**UNION COUNTY PUBLIC LIBRARY  
LIBRARY RENOVATIONS AND ADDITION**

**LWC Commission No. 22110.00**

**ADDENDUM #08  
DECEMBER 13, 2023**

5 DUPLEX SUMP PUMP DETAIL  
SCALE: NONE

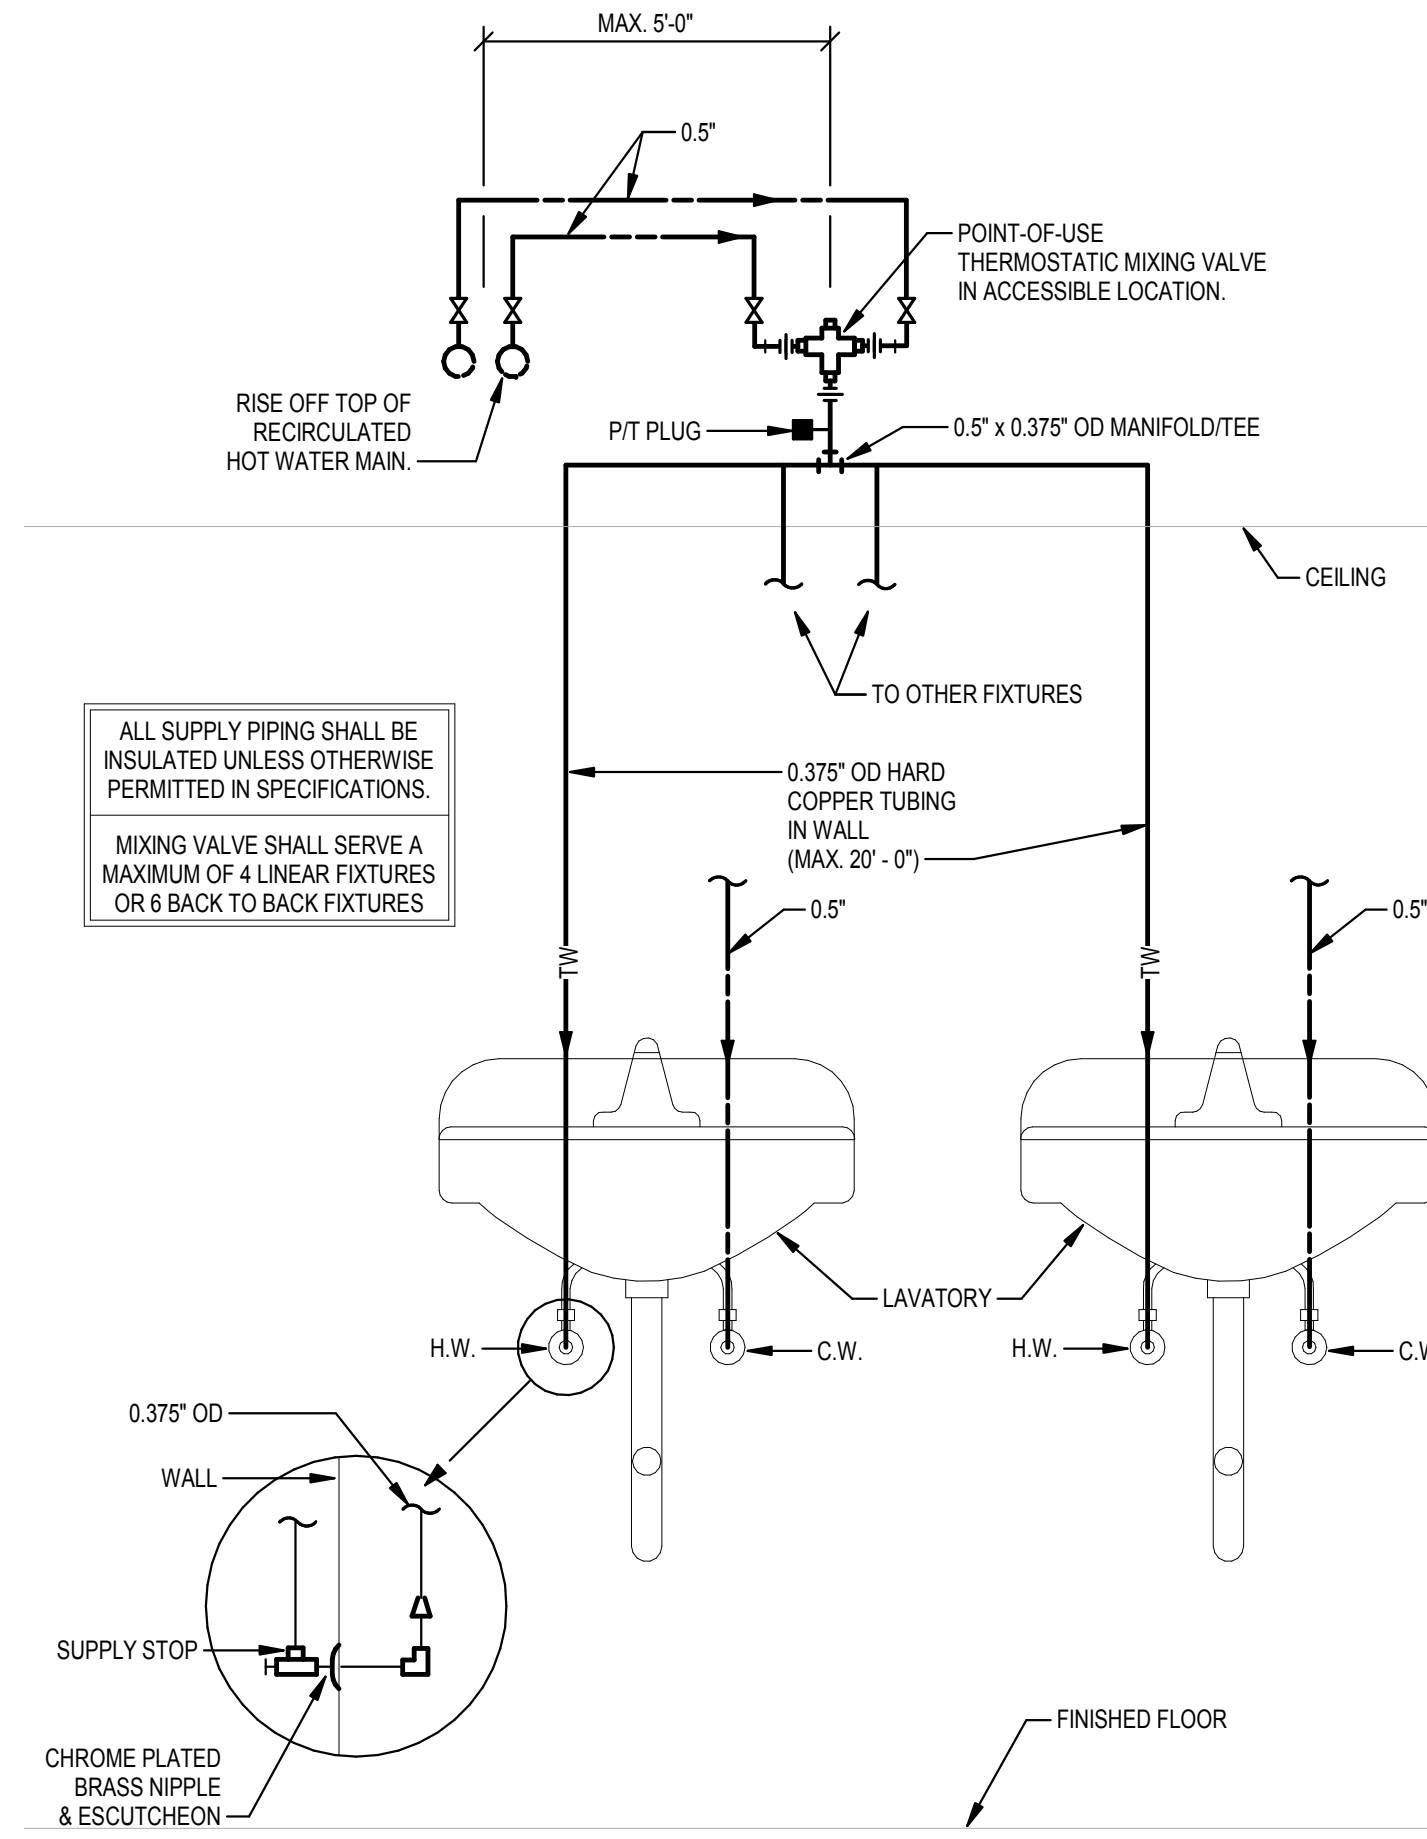
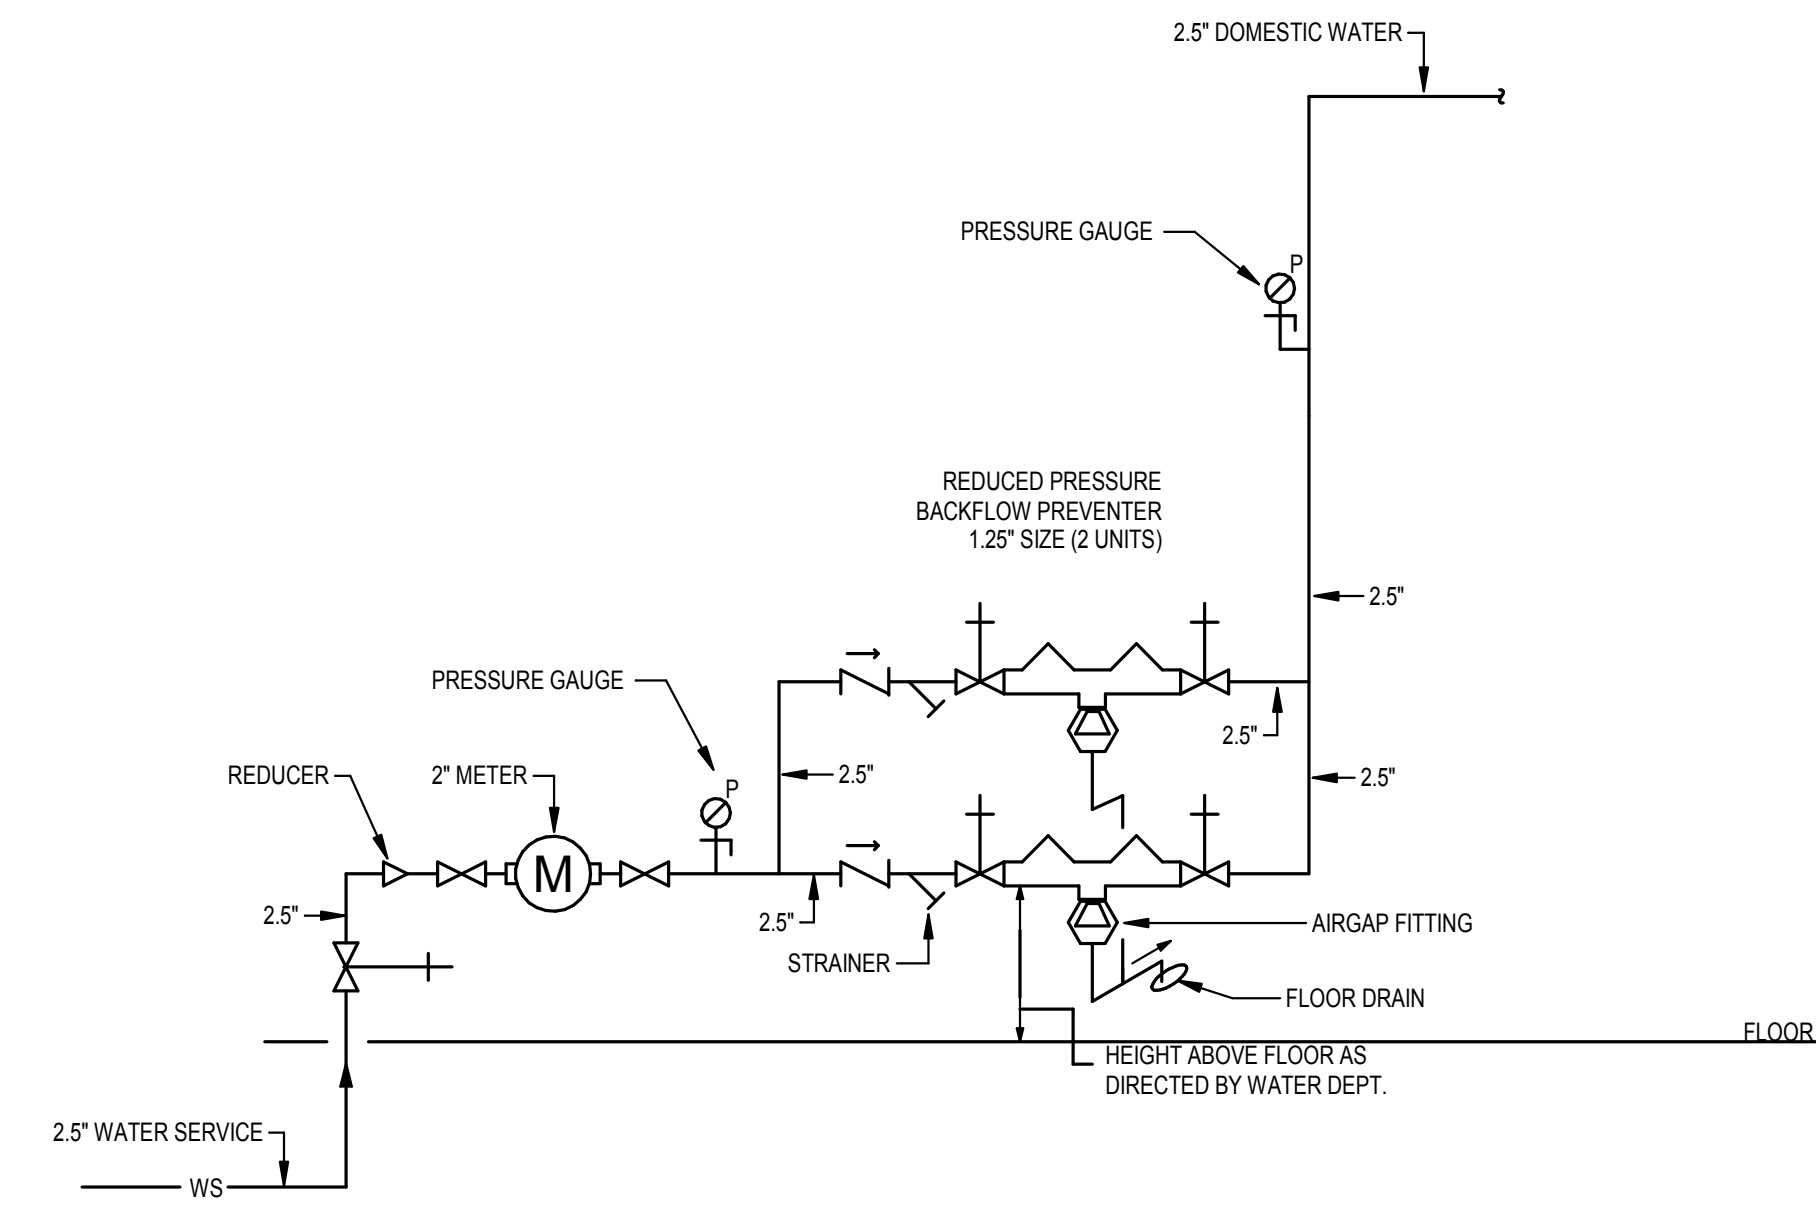
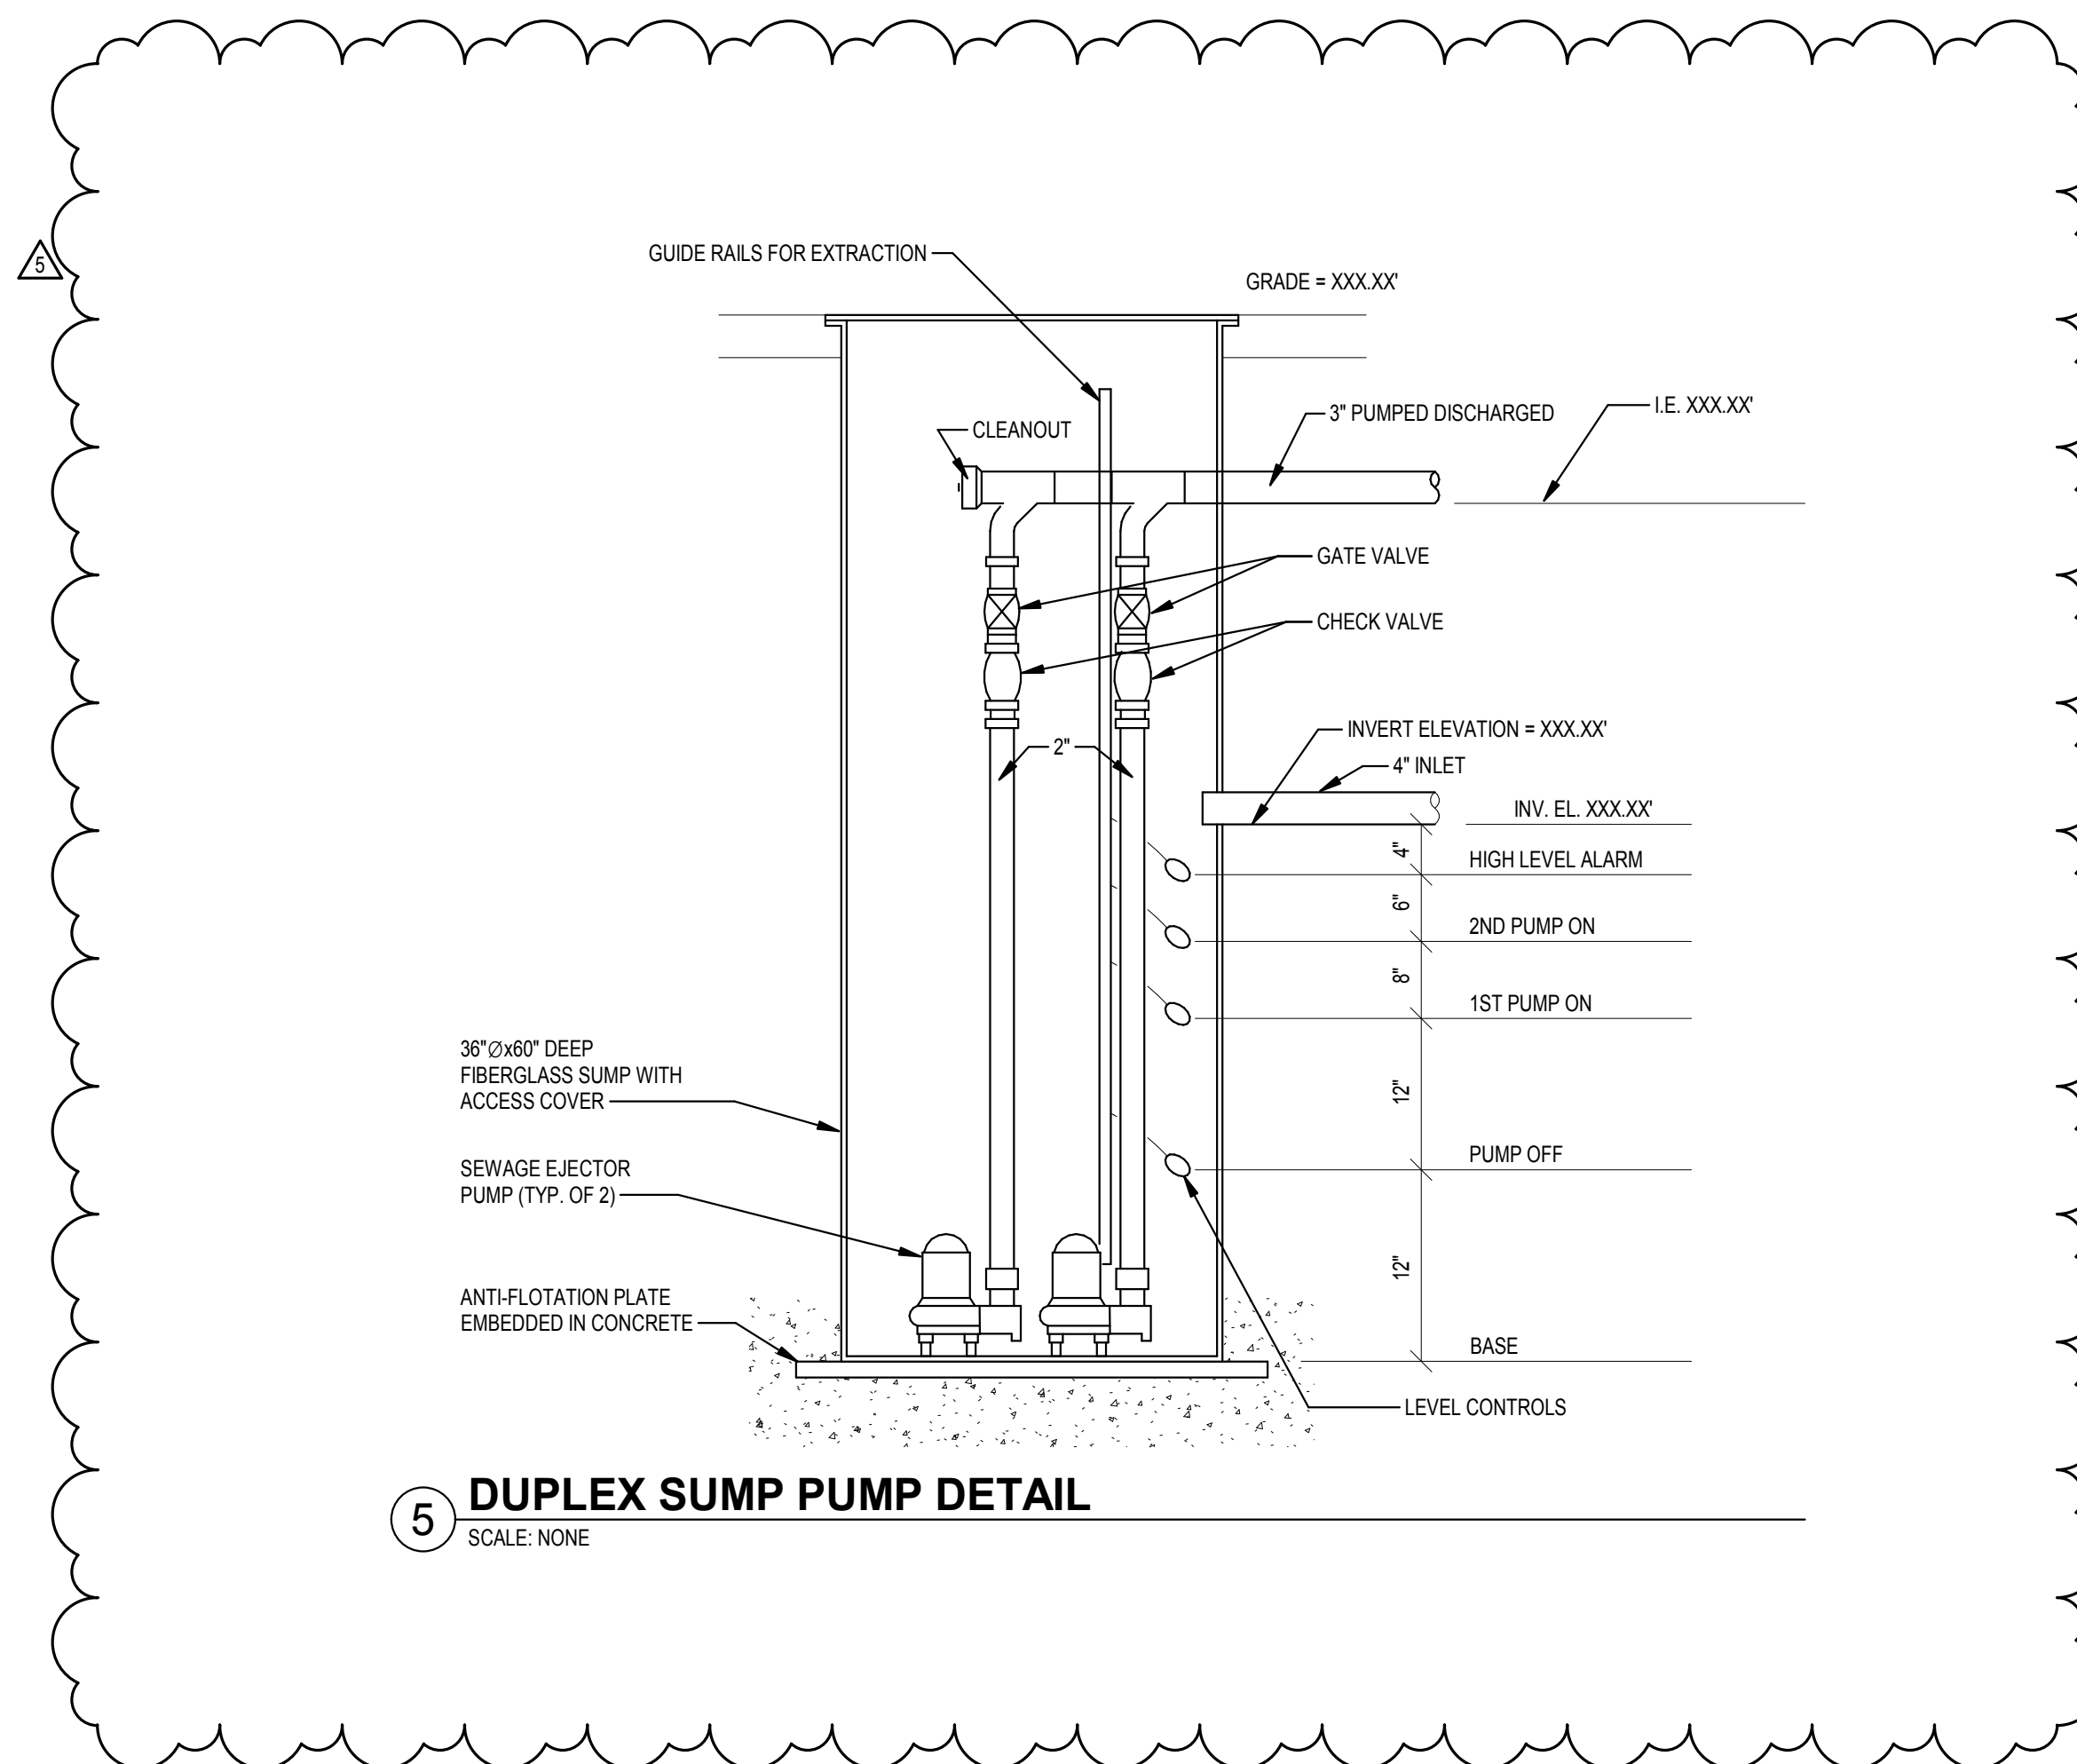
ITEM NO.3 – P502 – Plumbing Details

- Added sump pump
